Access Compliance Report

Public Rights-of-Way

(Curb Ramps)

Intersection ID: 10034609	Main Street: PLANTATION_CENTER_DR	Cross Street: N/A	Location: SE
ADA ID: 87ACB3E34E33	Ramp Type: Para	Initial Pass/Fail: Fail	Overall Compliance: No
Severity Score: 13.75			
Codes/Mitigation Info/Possible Solution		Field Measurements/Component Compliance

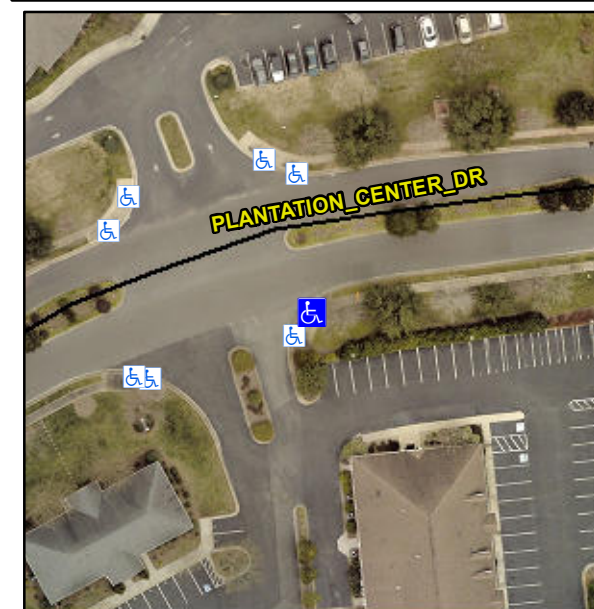
R304.3.2, R304.5.3

Compliance	Description	Data	Compliance	Description	Data
N/A	Ramp Length LT (in)	45.0	N/A	Ramp Length RT (in)	52.0
Yes	Ramp Width LT (in)	108.0	Yes	Ramp Width RT (in)	108.0
No	Ramp Slope LT (%)	8.9	No	Ramp Slope RT (%)	9.2
No	Ramp XSlope LT (%)	3.0	Yes	Ramp XSlope RT (%)	1.9
N/A	Landing Length (in)	N/A	N/A	DWS Provided?	N/A
N/A	Landing Width (in)	N/A	N/A	DWS Contrast?	N/A
N/A	Landing Slope (%)	N/A	N/A	DWS Length (in)	N/A
N/A	Landing X Slope (%)	N/A	N/A	DWS Full Width?	N/A
N/A	Landing Curb? (Y/N)	N/A	N/A	DWS Offset (in)	N/A
N/A	Shared Landing?	N/A			
N/A	Gutter Ponding?	N/A	N/A	Gutter Slope (%)	N/A
N/A	Gutter Lip Ht (in)	N/A	N/A	Gutter X Slope (%)	N/A
N/A	Painted X Walk1?	No	N/A	Painted X Walk2?	N/A
	X Walk 1 Direction	To NW		X Walk 2 Direction	N/A
N/A	X Walk 1 Width (in)	N/A	N/A	X Walk 2 Width (in)	N/A
	X Walk 1 Slope (%)	2.7		X Walk 2 Slope (%)	N/A
	X Walk 1 X Slope (%)	1.2		X Walk 2 X Slope (%)	N/A
N/A	Ramp inside XWalk1?	N/A	N/A	Ramp inside XWalk2?	N/A

Remove & Replace Entire Ramp.
